To: File, Taunton WWTP, NPDES No. MA0100897

Re: January 8, 2015 Supplemental Comments submitted by John Hall

Figure 22. Volume coverage as a function of temperature over the 1999 yearly simulation for various Brayton Point Station heat loads: MOA II (current operating condition), EMM (reduced heat operating condition), and no-plant operating scenarios.

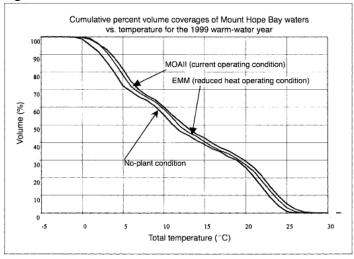
The temperature impacts noted in the 2015 memo from Swanson are the same as those presented in this 2006 article, see comparison of charts below. The one from the article shows 2 operating conditions and starts at -5° C but is substantively the same as the one we just got:

Figure 19. Plan view of daily mean water-column temperature for no-Plant hydrothermal model run on August 1, 1999.

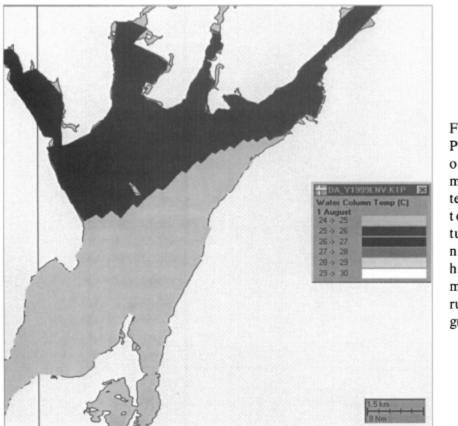
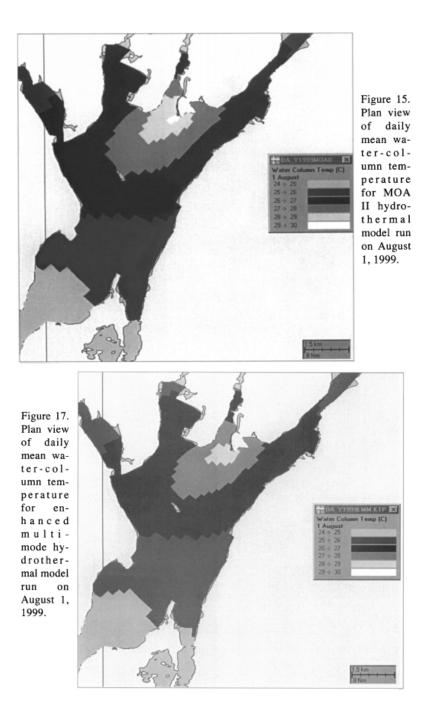
- 8. The thermal plume did not affect Taunton River temperatures. Swanson, 2006 at 153. Taunton River naturally has warmer temperatures than lower Mount Hope Bay. Swanson, 2006, Figure 19. Temperatures in the lower Bay with the thermal plume were actually similar to natural temperatures in the Taunton River. See Swanson, 2006, Figures 15 and 17. So the thermal conditions in 2004-06 actually made lower Mount Hope Bay more comparable to the Taunton River and the thermal studies do not indicate need to correct for impacts of eliminating the thermal plume if any could be shown.

Figure 20. Plan view of surface temperature differences for the EMM hydrothermal model run relative to the no-plant run at maximum ebb. Vertical cross-sectional view from the outfall is seen in the insert.

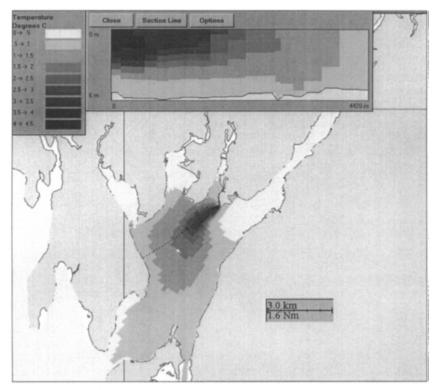
- 6. The temperature impact from eliminating the thermal plume is much less in bottom waters than the bay average (based on plume cross-sections in Swanson, 2006, Figures 20 and 21) so actual temperature difference (and related change in DO saturation) in the bottom waters where critical DO conditions exist is much less than suggested in the memo.
